**ELGEMS**

TO : Seung Lee – NRC fax 301-415-5369  
FROM : Sergio Steinfeld – Elgems  
CC : Jim Beebe – GEMS fax 414-548-5197

The letter bellow (7 pages) provides the required information you asked on our telephone conversation on 28/10/99 and later in your E-mail of 2/11/99.

REVISE PER EDCB NO. 92205-184	APPROVAL	DATE
		10/14/99

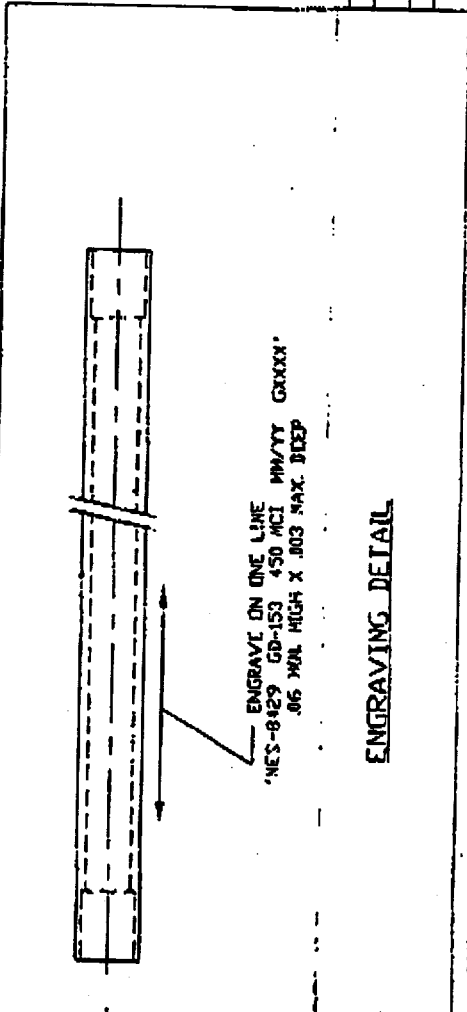
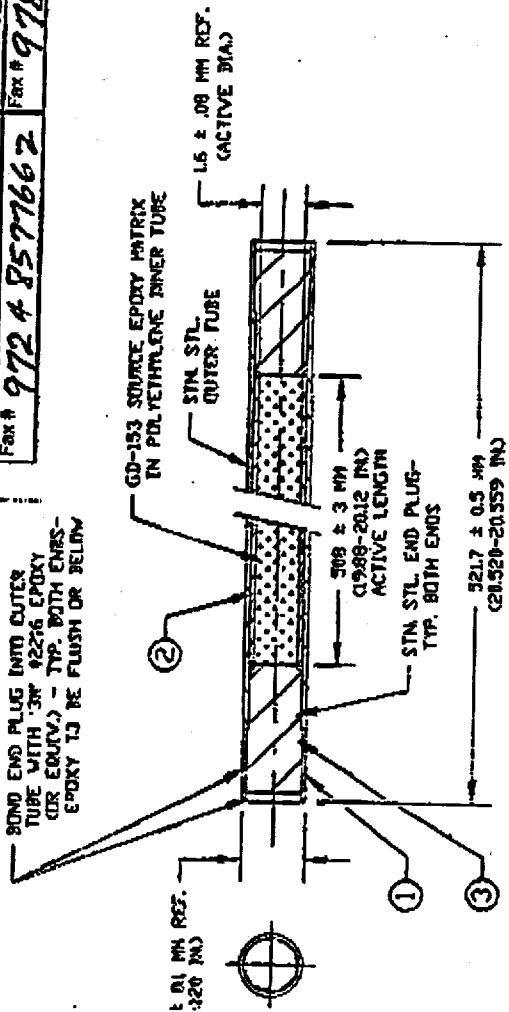
Pages 2 and 3 were provided from DuPont. Specific installation instruction was added to assure visibility of the engraving of the line source after gluing it into the source holder.

**SOURCE INSTALLATION DETAIL**

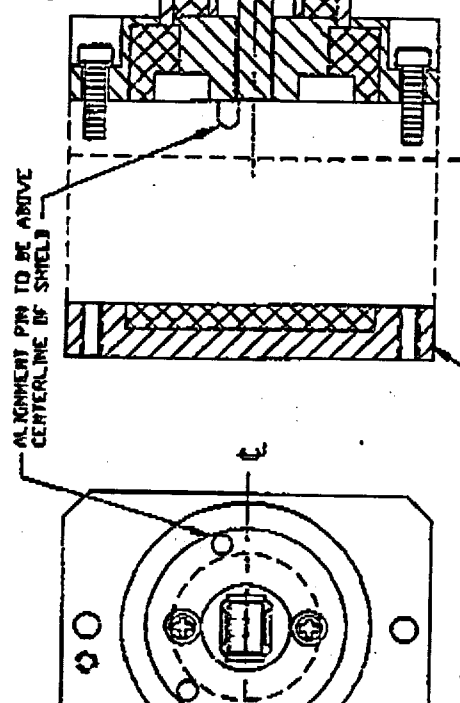
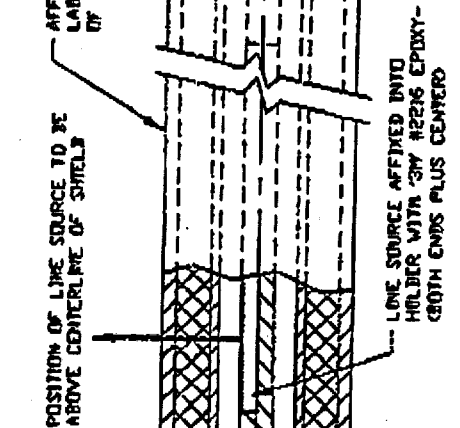
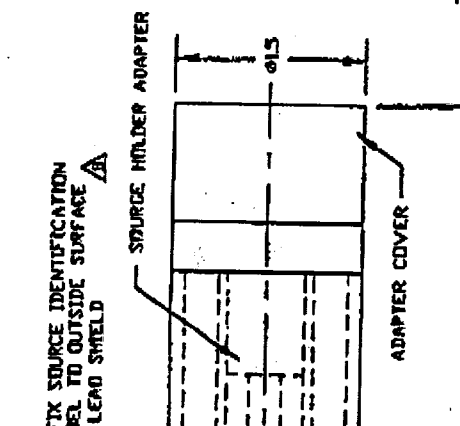
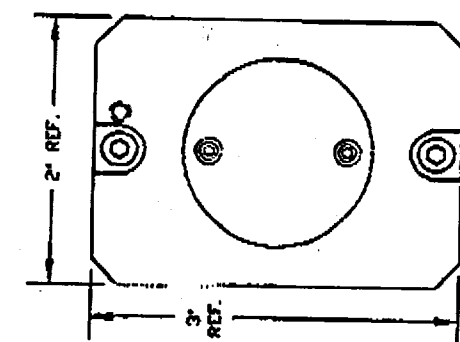
See page 3 (Drawing B003564 , top of the page) :

“ SOURCE INSTALLATION INSTRUCTIONS “

row 2 “ EPOXY LINE SOURCE INTO GROOVE OF SOURCE HOLDER (SEE DEATIL B)

DETAIL B clearly instruct how to load the line source into the groove : “ ENGRAVING TO BE VISIBLE WITH SOURCE EPOXIED IN HOLDER”.

REMOVE ADAPTER COVER AND SOURCE HOLDER COVER  
 EPOXY LINE SOURCE INTO GROOVE OF SOURCE HOLDER (SEE DETAIL A)  
 INSERT SOURCE HOLDER GEAR WITH THREADED HOLE  
 FIRST INTO SHIELD AND ATTACH ADAPTER  
 AFFIX ADAPTER COVER ONTO SHIELD WITH SCREWS  
 AFFIX SOURCE HOLDER COVER ONTO SHIELD WITH SCREWS

ENGRAVING TO BE VISIBLE WITH SOURCE EPOXYED IN HOLDER
